UNITED STATES PATENT AND TRADEMARK OFFICE

APPLICATION NO.	FILING DATE	FIRST NAMED INVENTOR	ATTORNEY DOCKET NO.	CONFIRMATION NO.
09/940,949	08/28/2001	Luc Tripod	PU010180	5192

Office Action Summary

DETAILED ACTION

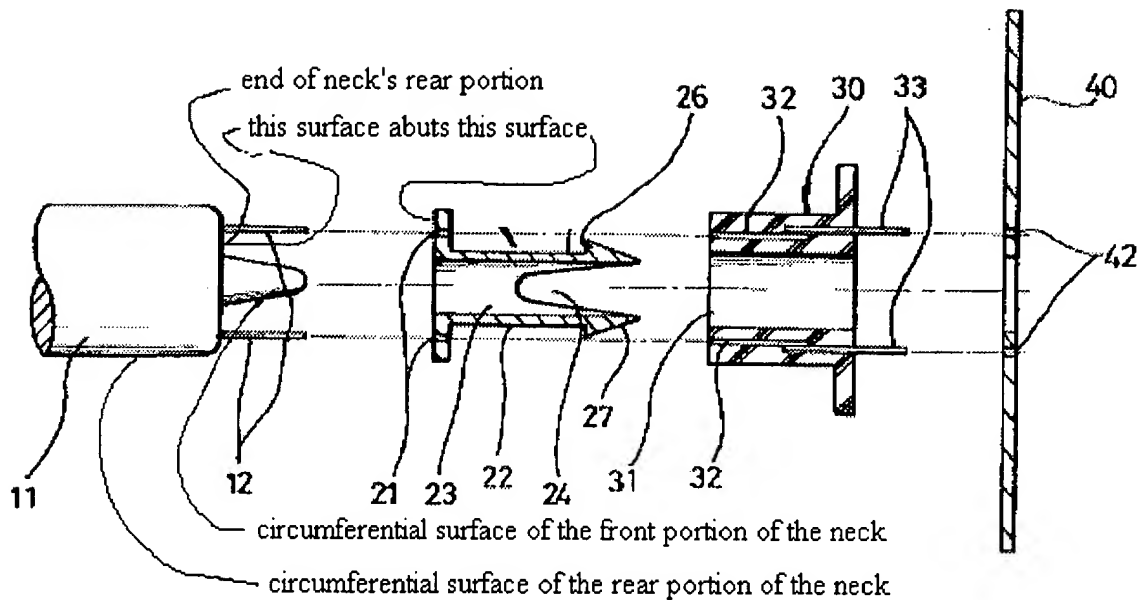
- Claim(s) 1 –8 are rejected under 35 U.S.C. 102(b) as being anticipated by Cho (5963275).
-- In reference to claim 1, Cho shows (cover sheet) an arrangement for coupling a cathode ray tube (CRT) (figure 4) to a socket 30 which is mounted on a circuit board 40 the CRT having a funnel 10 and a neck (see examiner's figure) having an end (see examiner's figure), a circumferential surface and terminals 12 extending from the electron gun along the circumferential surface (the circumferential surface of the front portion of the neck), the circuit board 40 being positioned with a first side facing the funnel portion and a second side facing away from the funnel portion, the socket having electrical contacts 33 which engage the terminal on the CRT 12, the electrical contacts being positioned on the second side of the circuit board (figure 9).

Although the prior art does not specifically disclose the claimed terminals 12 extending from the electron gun, this feature is seen to be an inherent teaching of that device since the electron gun is within the neck and behind the terminals 12.

-- In reference to claim 4, Cho shows the socket has a back cover 20 (figure 7) which abuts a distal end of the neck (see examiner's figure and indicator lines stating "this surface abuts this surface").

-- In reference to claim 5, Cho shows (see examiner's figure) a funnel and an integral neck extending rearward from the funnel (figure 4);

-- In reference to claim 6, shows the terminals extend along an outer circumferential surface of the neck (see examiner's figure).

-- In reference to claim 7, shows (see examiner's figure) the socket has a back cover 20 (figure 7) which abuts a distal end of the neck.
